STATE OF DELAWARE  
**DEPARTMENT OF TRANSPORTATION**  
800 BAY ROAD  
P.O. BOX 778  
DOVER, DELAWARE 19903

June 4, 2020

RE: Agreement No. 1774  
Project Number T201769002  
Traffic Impact Study Services  
**Subtask 1B-2-Poole Farms TOA**

Johnson, Mirmiran and Thompson (JMT) has completed the review of the Traffic Operational Analysis (TOA) for Poole Farms, prepared by The Traffic Group, Inc. dated September 19, 2019. This task was assigned as Subtask Number 1B-2. The report is prepared in a manner generally consistent with DelDOT's *Development Coordination Manual*.

**Site Map**

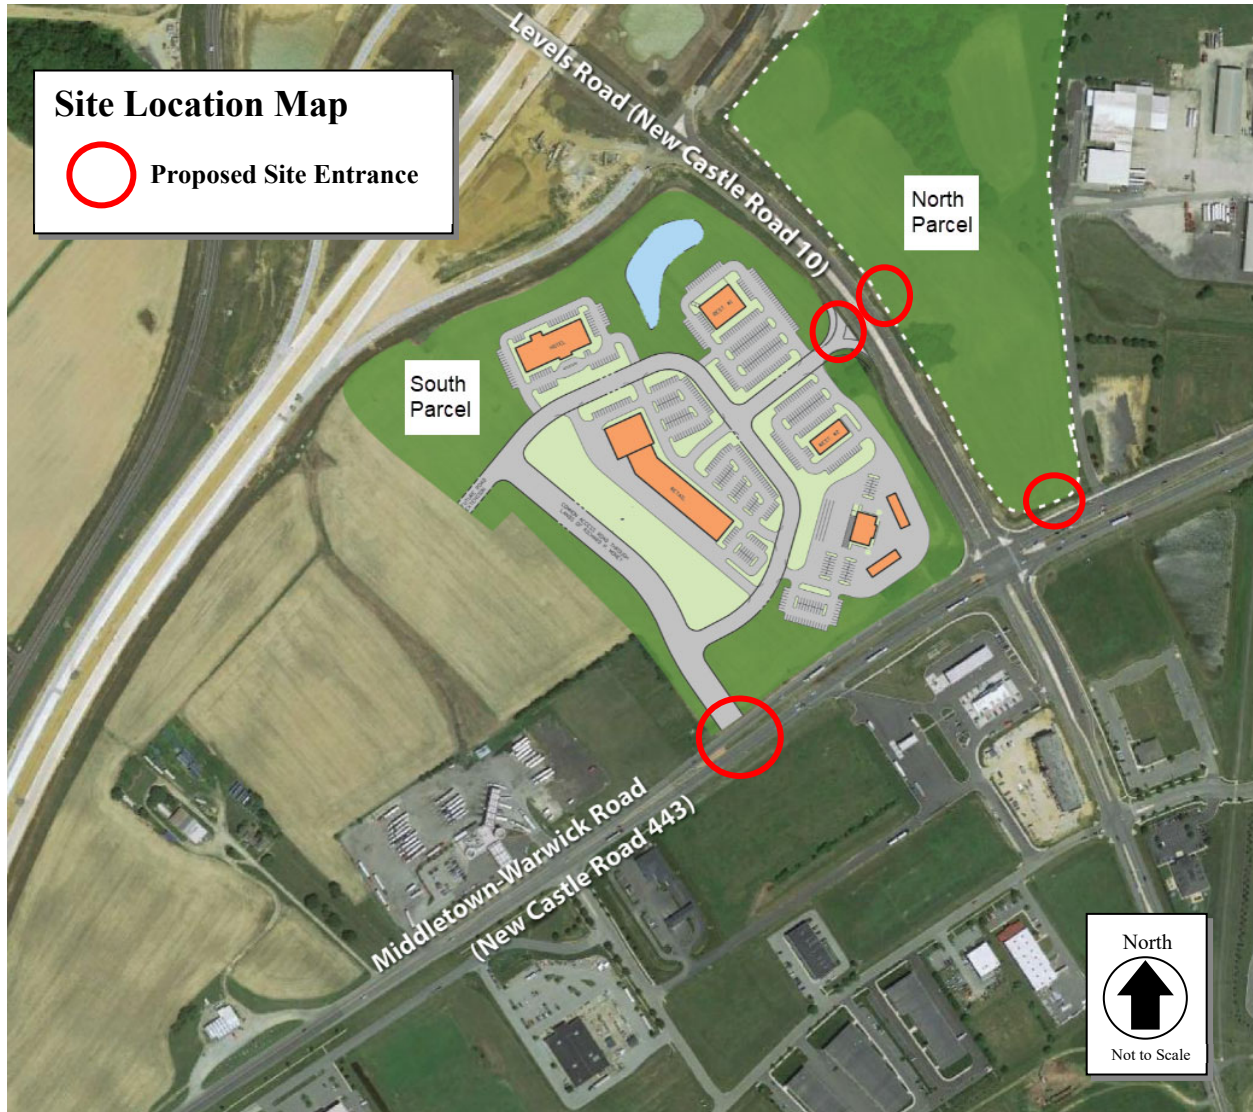
*\*Graphic is an approximation based on the Concept Plan prepared by Woodin and Associates dated June 17, 2019.*
